Able Marine Energy Park

Material Change 2

Responses to Questions

RESPONSE TO THE EXAMINING BODY'S WRITTEN QUESTIONS AND REQUESTS FOR INFORMATION (EXQ1)

**ZONE OF THEORETICAL VISIBILITY
BARE EARTH: CRANE 200M**

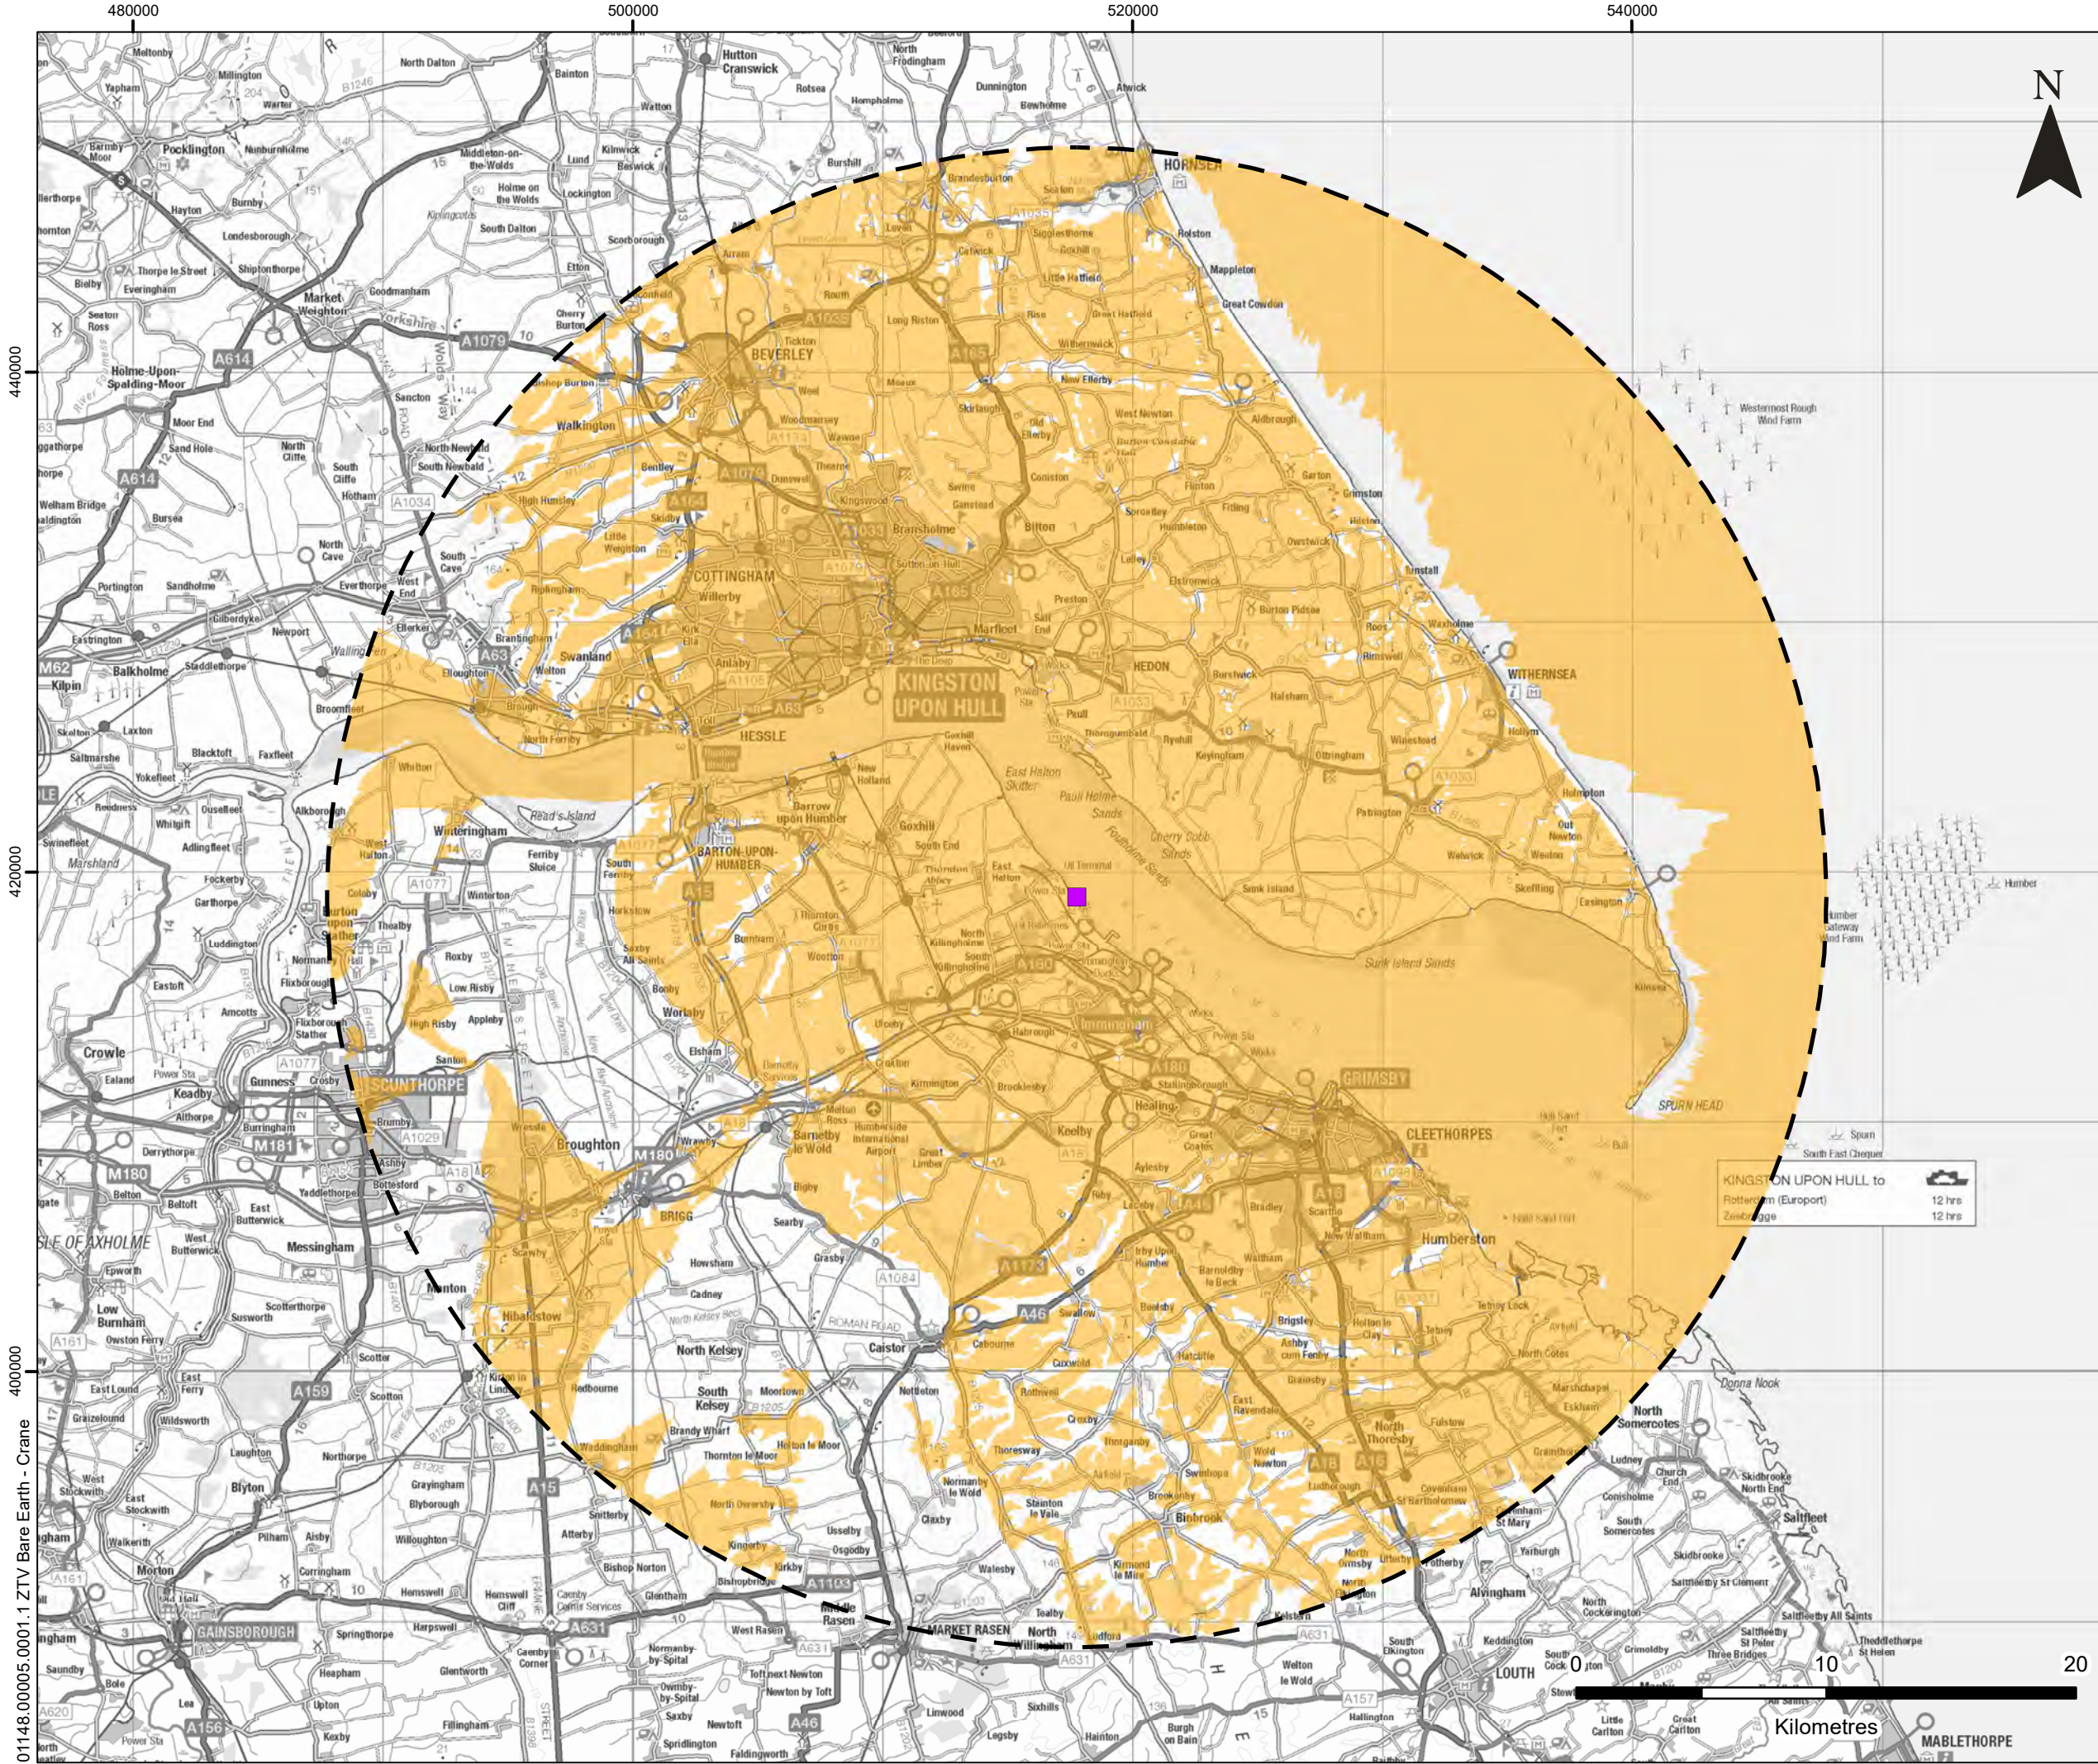
- Q9.07 - Please prepare material showing zones of visibility for the cranes in relation to heritage assets, landscape, and residential receptors.
- Q9.08 - Please show descriptively and diagrammatically, including through photomontages updated from the original ES and new photomontages if necessary, the effects of the taller cranes and their lighting on these receptors, including their night-time effects. Show this with reference to the LVIA prepared for Chapter 20 of the original ES, and the analysis of Heritage setting effects undertaken for the ES (Annex 18.4).
- Q9.09 - Useful updated photomontages would be: VP1, VP2, VP3, VP4, VP8, VP13 and VP17. However, the choice may depend on the zone of visibility and it would be helpful to have sight of this in outline form as soon as possible.

2.1 Appendix A includes Figure 1: Zone of Theoretical Visibility (ZTV), which illustrates the area where a proposed crane with a total height of 200m and located on the quayside, may be theoretically viewed. The ZTV has been produced based upon a 'bare earth' scenario where features of the landscape such as buildings, structures and vegetation are not modelled. It is acknowledged that these features have potential to provide screening of the proposed crane and as such the ZTV is used as a basis of determining likely receptors locations and the subsequent testing of visibility within the field. It should be regarded as a worst-case scenario only and not a true representation of actual visibility.

2.3 Figure 1 illustrates that there would be a marginal increase in the extent of the areas where the proposed crane would be visible compared to the ZTV for the wind turbines. This is predominantly within the south and south west of the study area and within areas in excess of 20km from the site. There would be no change to the extent of visibility within 10km of the site.

- 5.1 This report provides a response to written questions and requests for information (ExQ1) including Q9.07, Q9.08 and Q9.09.
- 5.2 In response to Q9.07, a ZTV which illustrates the area where a proposed crane with a total height of 200m located on the quayside has been provided in Figure 1. Comparison of this with Figure 20.3a from the original ES indicates that there would be a marginal increase in visibility of this structure. However, the additional areas are all in excess of 20km of the site and therefore in reality the additional structure in the view is likely to be barely perceivable.
